FLAP RAC CONTROL

SLAT RAC CONTROL

S/N 029

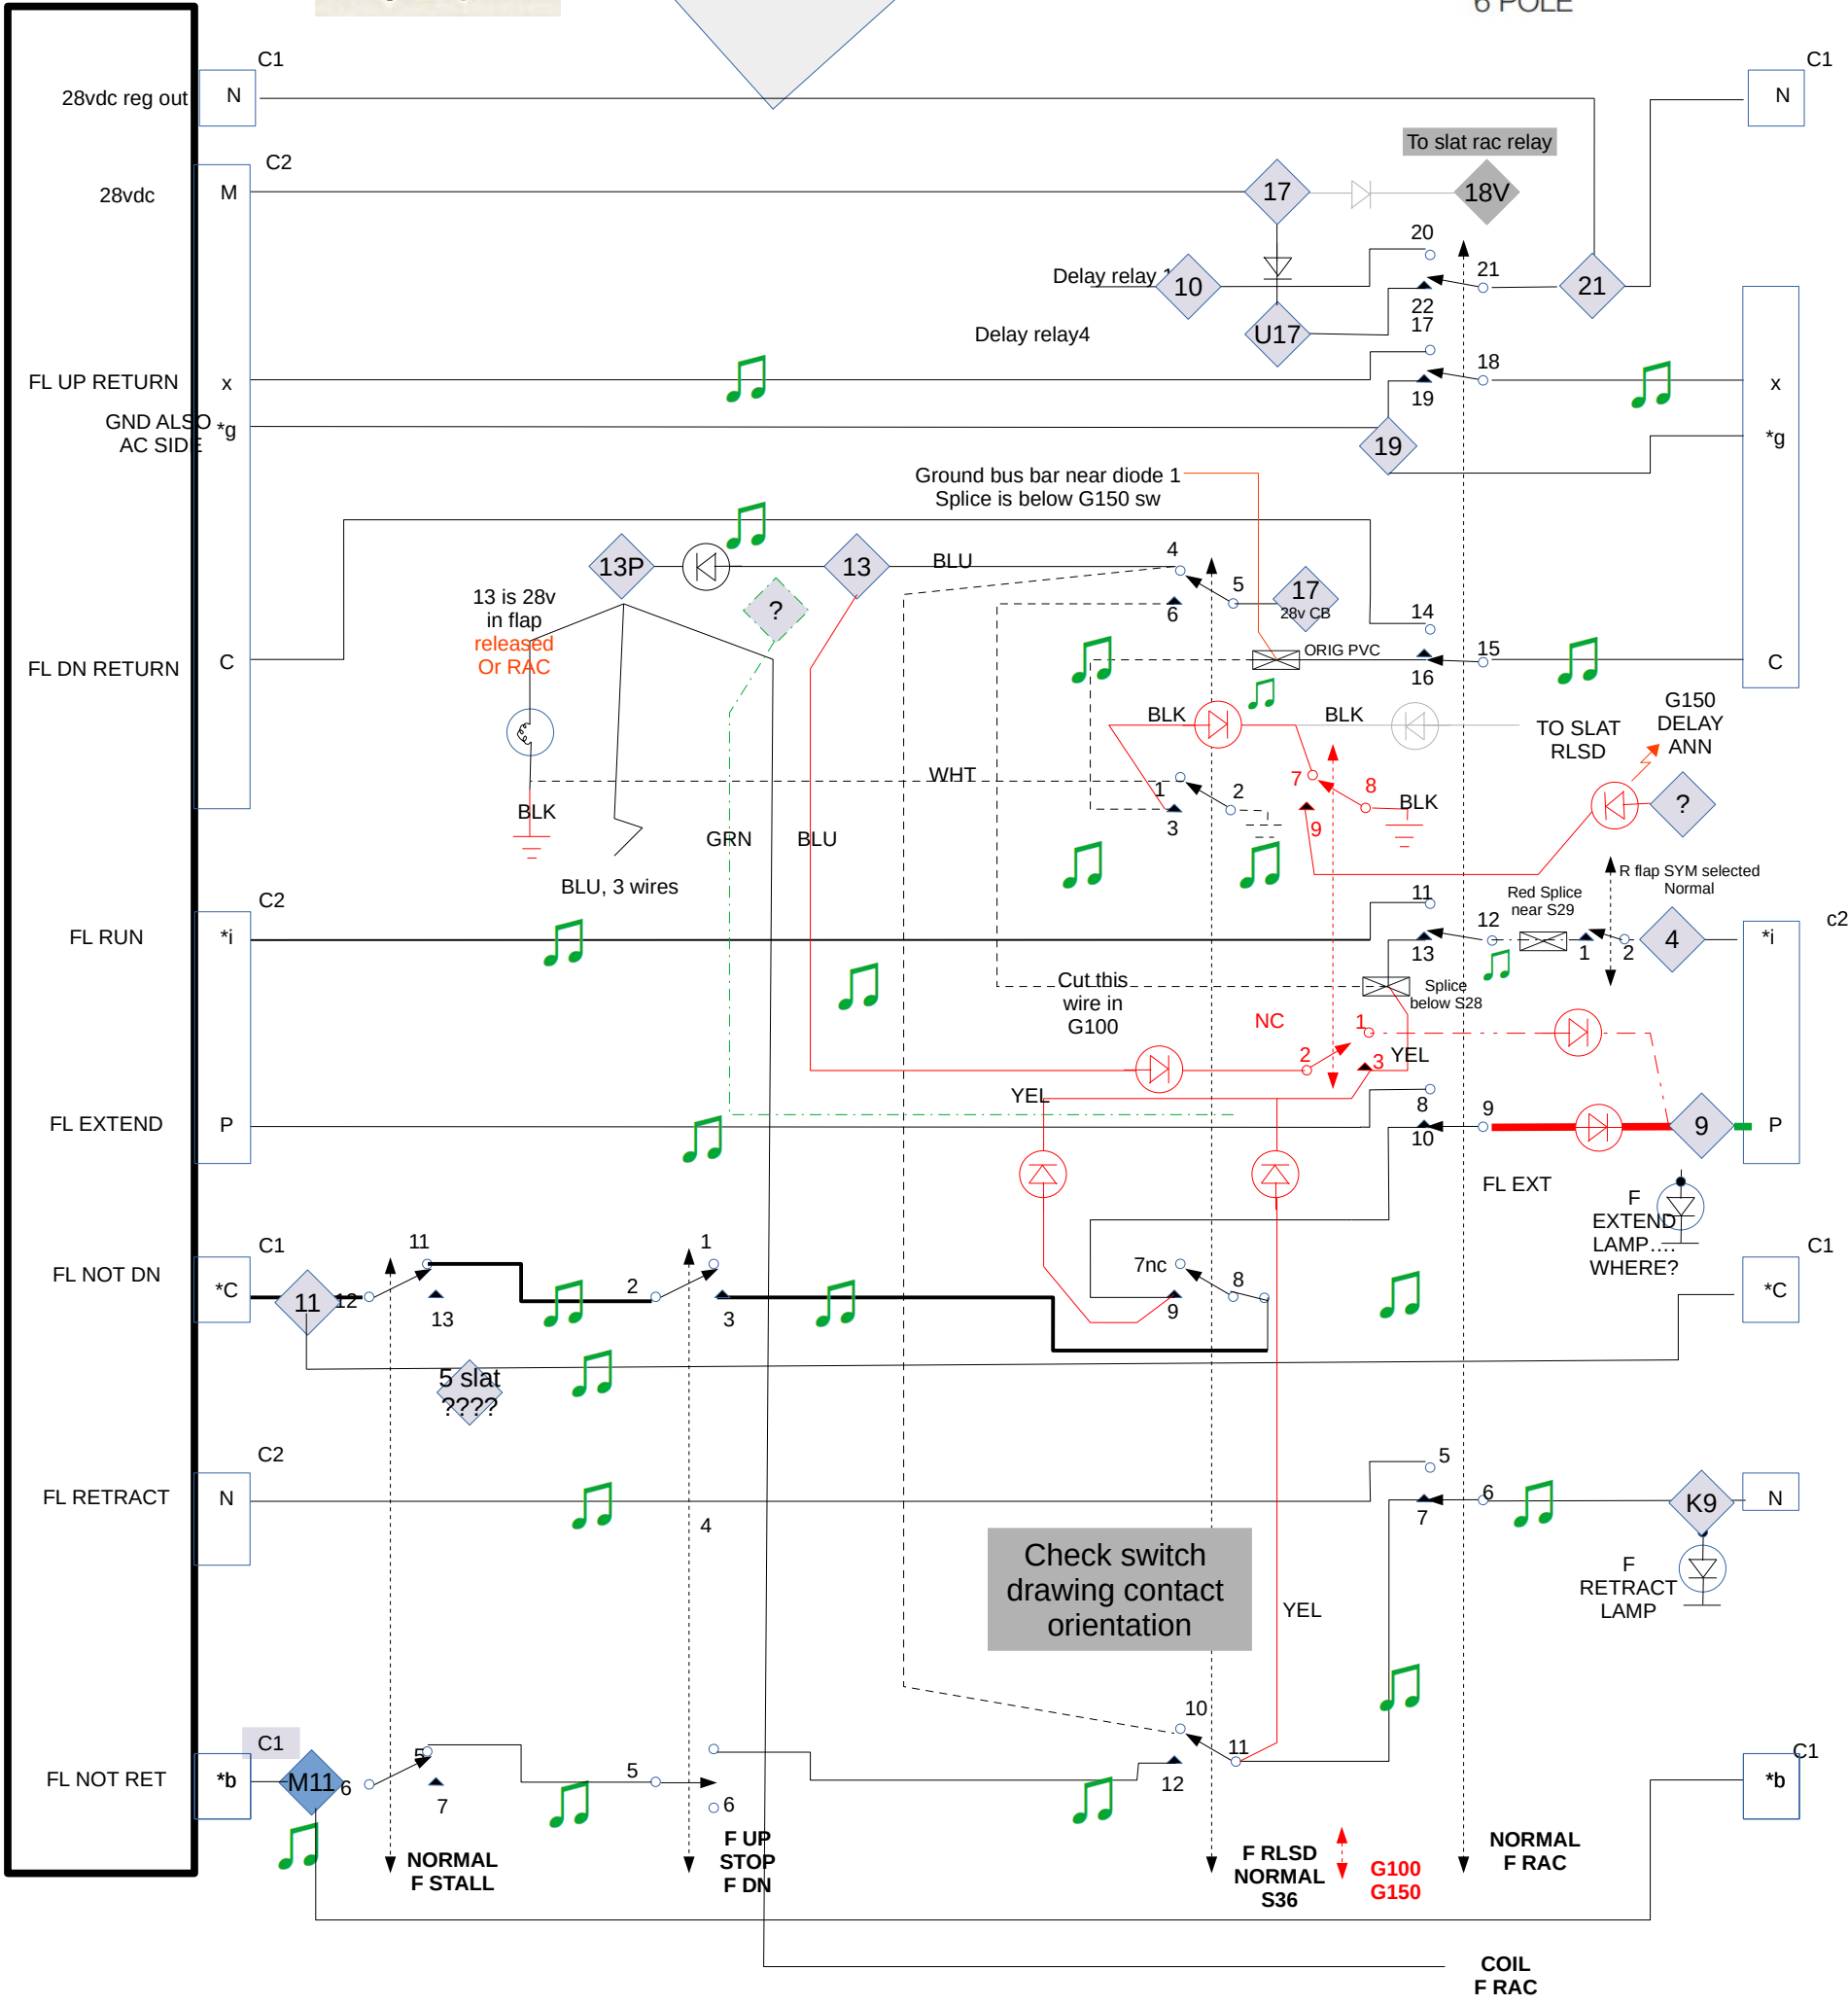
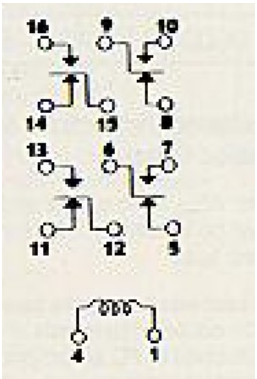
Red lines
are added
wires for
G150
delay

Dashed
lines are
original
wires to
be
removed

SLAT DOWN RETURN IS NOT
ACTIVE IN S RLSD WHEN MOD
BEGAN

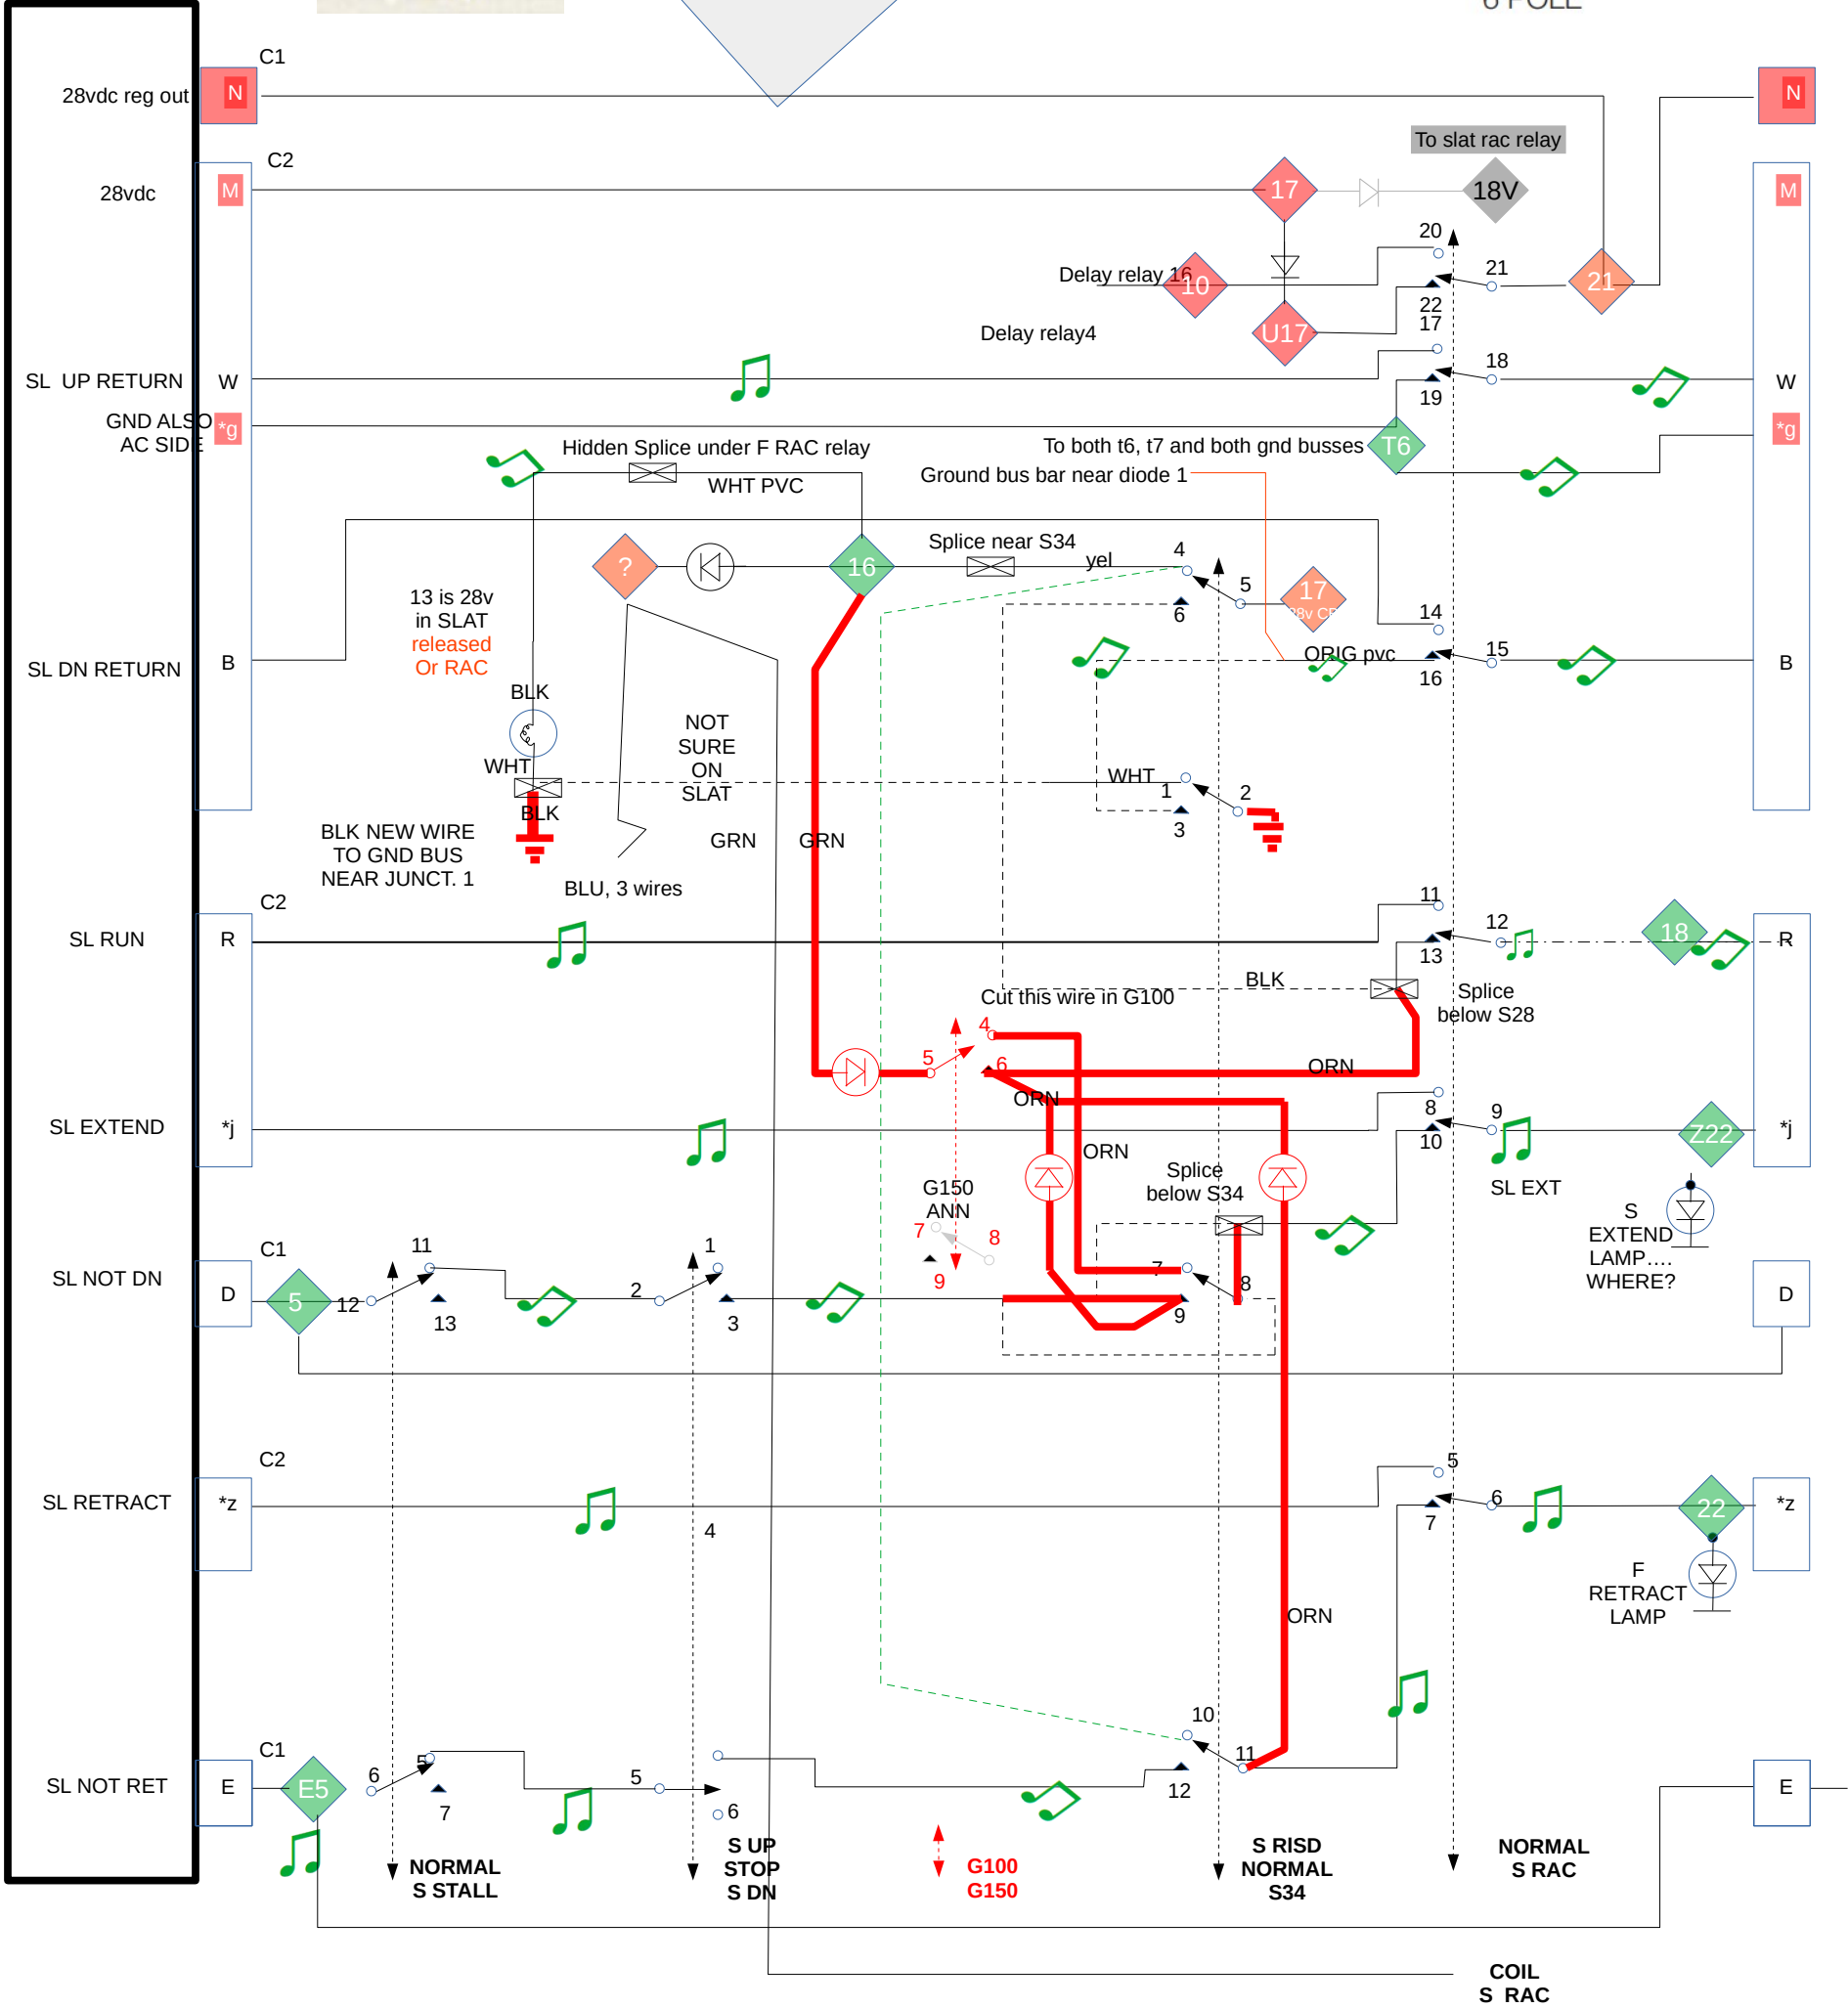
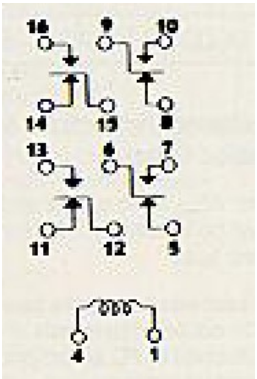
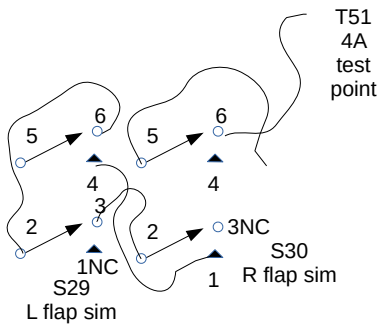
STRAIGHT NOTE
IS COPY /PASTE
FROM FLAP
CIRCUIT

SLANTED NOTE IS
RUNG OUT ON
SLAT CIRCUIT

Red lines
are added
wires for
G150
delay

Dashed
lines are
original
wires to
be
removed
